FIRE SERVICE AGENCY REVIEW

Address of Site 17865 NW St Helens Rd, Portland, OR 97231
 Map & Tax Lot: T2N,R1W,S18D00700 'R' number R971180290
 Description of Proposed Use: Muslim cemetery
 Total Square Footage of Building (including roof projections, eaves & attached structures): 0
 Applicant Name: Razib Shishir Phone: 5032095476
 Mailing Address: 14285 NW Old Germantown Rd
 City: Portland State: OR Zip Code: 97231 Email: rsshishir@yahoo.com

COOL ISLAM
MUSLIM CEMETERY
17865 NW ST HELENS ROAD
PORTLAND, OREGON 97231

SHEET TITLE
PROPOSED
SITE PLAN

1 PROPOSED SITE PLAN

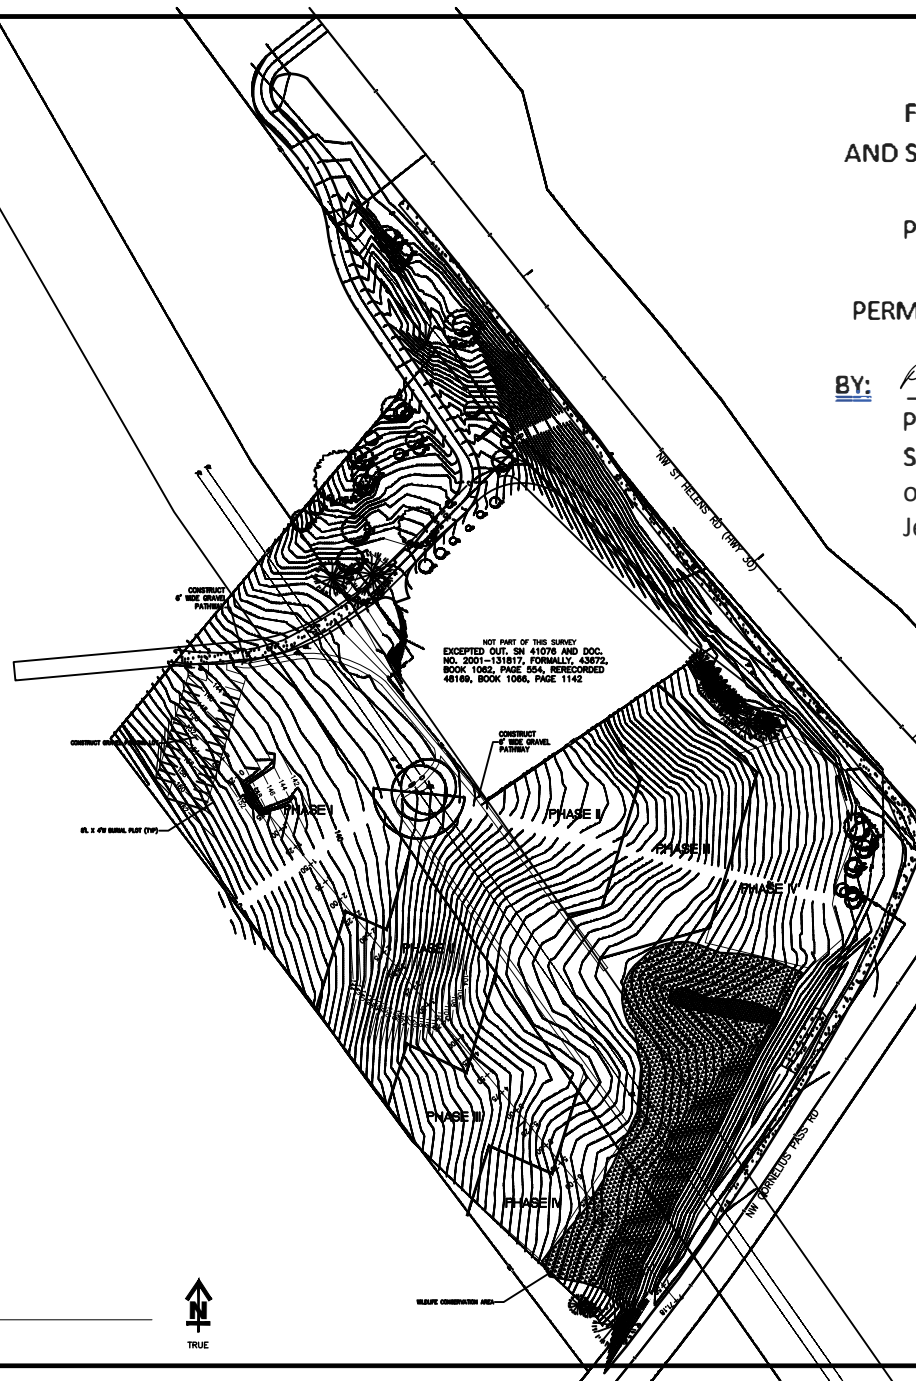
- ☒ The proposed development is in compliance with the fire apparatus access standards of the Oregon Fire Code standards as implemented by our agency.
- ☐ The following access improvements must be completed prior to issuance of the building permit and be re-inspected by our agency before flammable materials are placed on the property.

- ☒ The proposed non-commercial structure **is less than 3,600 sq. ft.** (including the horizontal projections of the roof) and there **is** 1,000 gallons per minute of fire-flow available at 20 psi from public water lines. No mitigation measures are necessary.

- ☒ The minimum fire flow and flow duration is available from public water lines or private well as specified in Appendix B, Table B105.1. No mitigation measures are required.
- ☐ The minimum fire flow & flow duration is not available from public water lines or private well as specified in Appendix B, Table B105.1. The following mitigation measures are required:

APPROVED
FOR CONDITIONS SHOWN
AND SUBJECT TO FINAL INSPECTION
FIRE MARSHAL
PORTLAND FIRE & RESCUE
PORTLAND, OR
